Service Bulletin

PRELIMINARY INFORMATION

Subject: Pop out of third gear

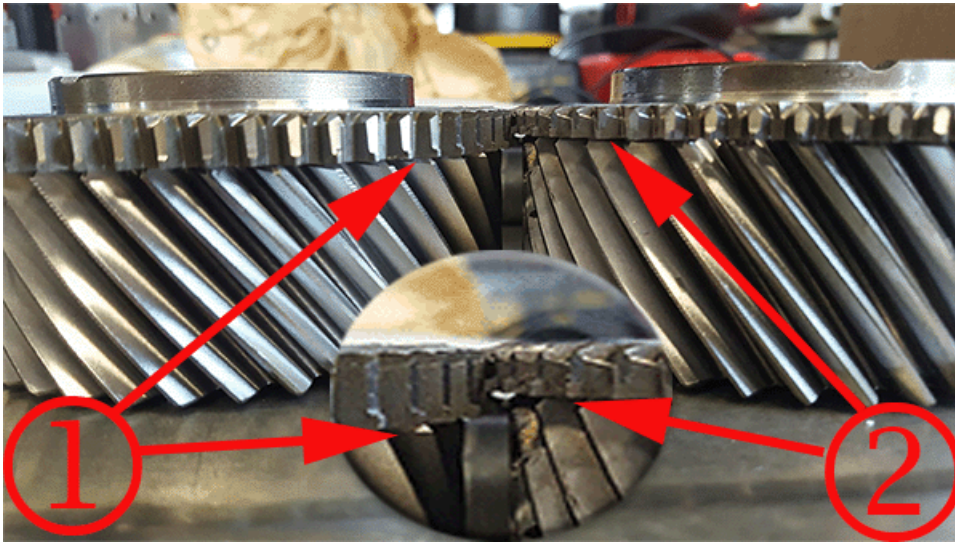
Involved Region or Country	North America
Additional RPO/s:	N/A
Condition	Dealer may notice a hop out of third gear condition during pdi or customer may return with very low mileage with a hop out of third gear.
Cause	Mis-machined third gear installed into the transmission.

For vehicles that are noticed during normal PDI or customer has returned with a hop/jump out of third gear concern that has been verified, replace the third speed gear, synchronizer and shift collar. Below are pictures of the incorrectly machined gear (2) and the correctly machined gear (1). None of the incorrect gears (2) were ever shipped to or stocked by CC&A.

If there is a hop out of third gear concern noted then the transmission will need to be repaired, replacing the third speed gear, synchronizer and shift collar
For transmissions needing internal repairs please see Main Shaft and Input Shaft Disassemble for the appropriate vehicle.
